BULLETIN

NUMBER: 149

SUBJECT: Reinforcement of Aileron Balance Weight Bracket

MODELS AFFECTED: PA-23 - Serials 23-1 to 23-731 inclusive; 23-733; 23-734; 23-735; 23-737; 23-738; 23-742 to 23-768 inclusive; 23-770 to 23-776 inclusive; 23-778 to 23-783 inclusive; 23-785; 23-786; 23-788 to 23-793 inclusive; 23-795; 23-796; 23-798 and 23-800

AILERON BALANCE BALANCE ASSY	
SERVICE BULLETIN	149
PIPER AIRCRAFT CORP.	
LOCK HAVEN, PA.

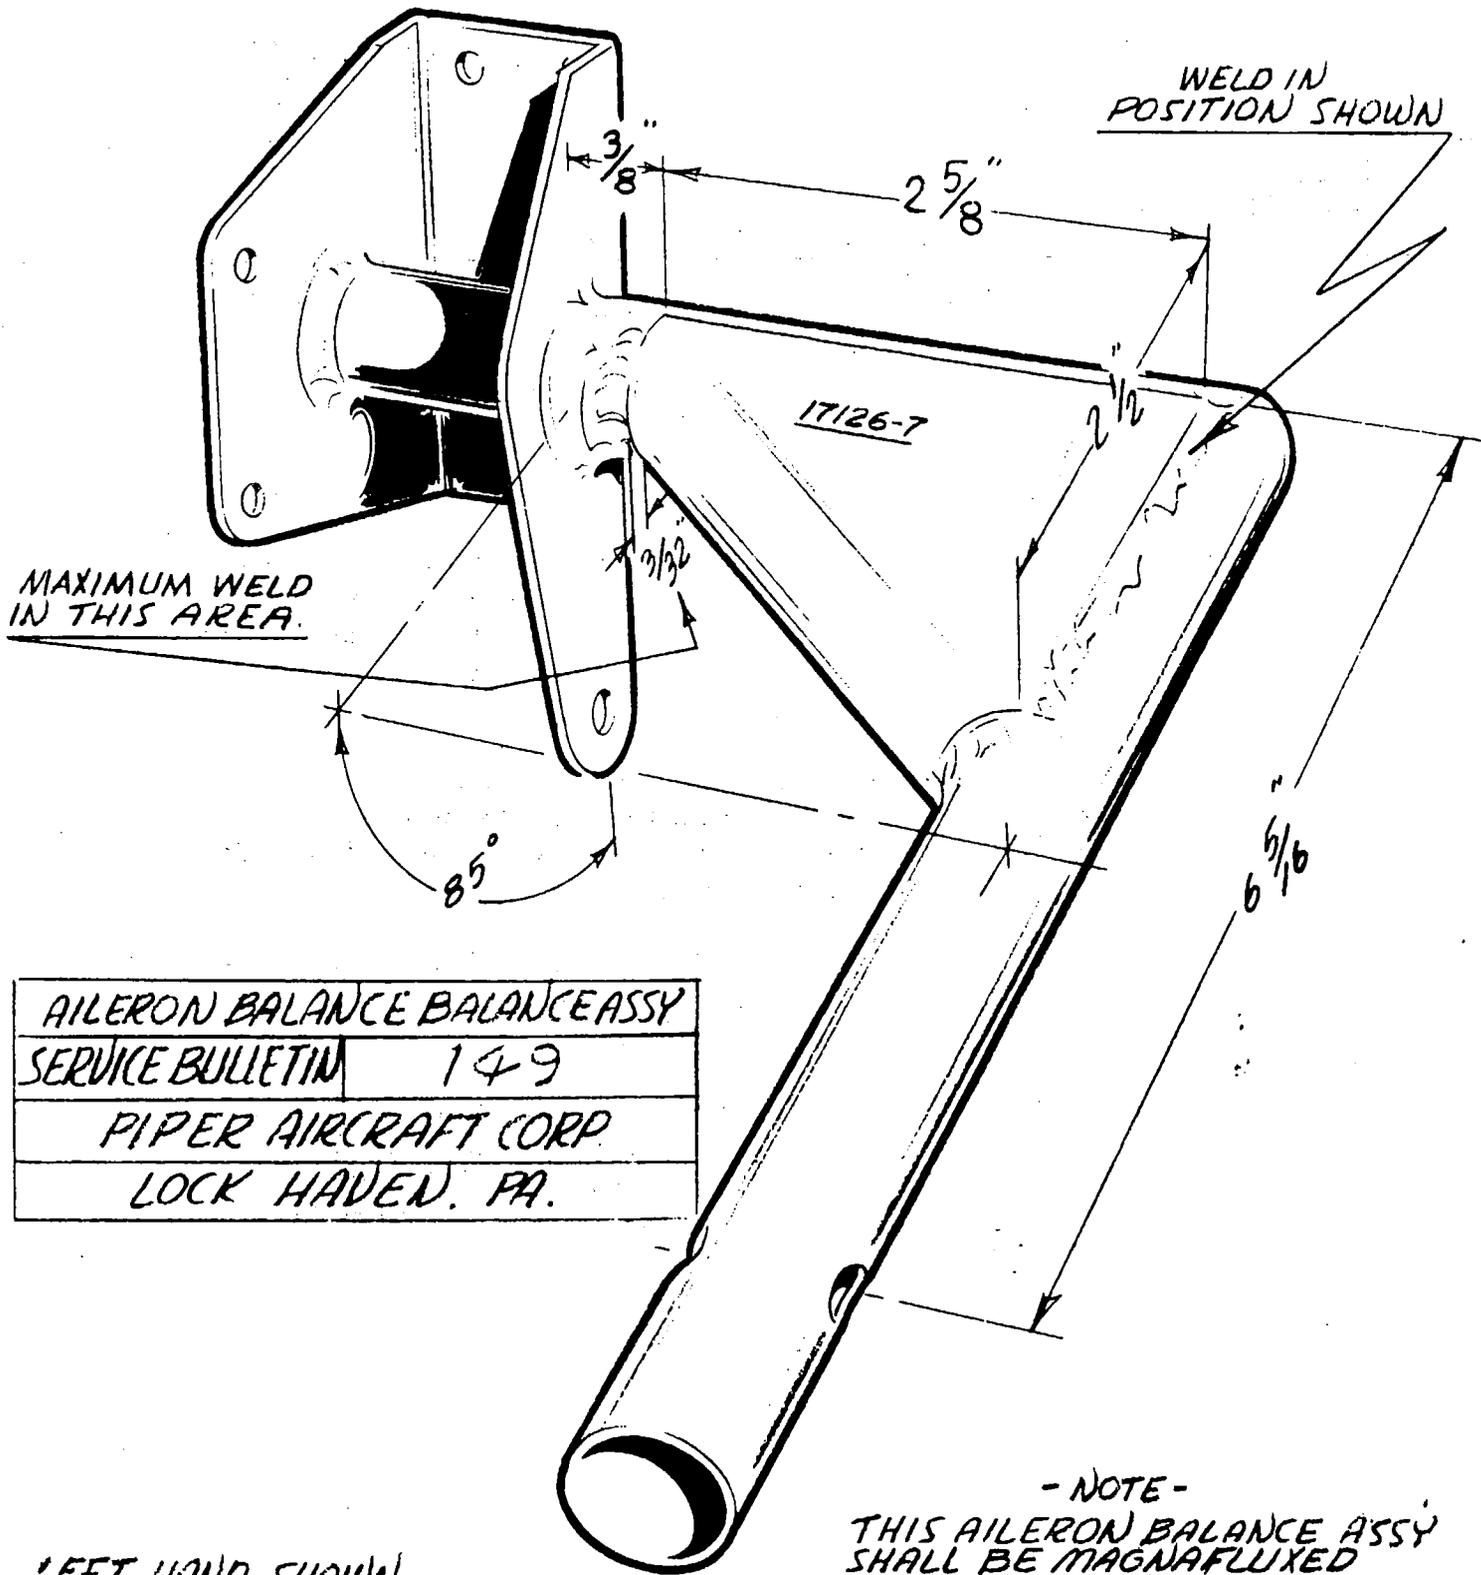
Several cases of fatigue cracking in the aileron balance weight bracket at a point where the bracket tubes are welded to form a 90° angle have been reported. Therefore, on the above listed aircraft it will be necessary to remove both the right and left aileron balance weight brackets and reinforce them in accordance with the Sketch shown on the reverse side of this Bulletin.

In cases where cracks are found, they are to be cleaned of paint and rewelded prior to the addition of the reinforcement. After the reinforcement gusset has been welded to the aileron balance bracket, the bracket is to be magnafluxed for welding cracks and thoroughly checked for straightness.

Further, it is requested that prior to the installation of the reinforcement bracket an inspection should be made of the fit between the balance weight itself and the balance weight bracket and any looseness at this point corrected.

- NOTE -
THIS AILERON BALANCE ASSY
SHALL BE MAGNAFLUXED
AFTER WELDING.
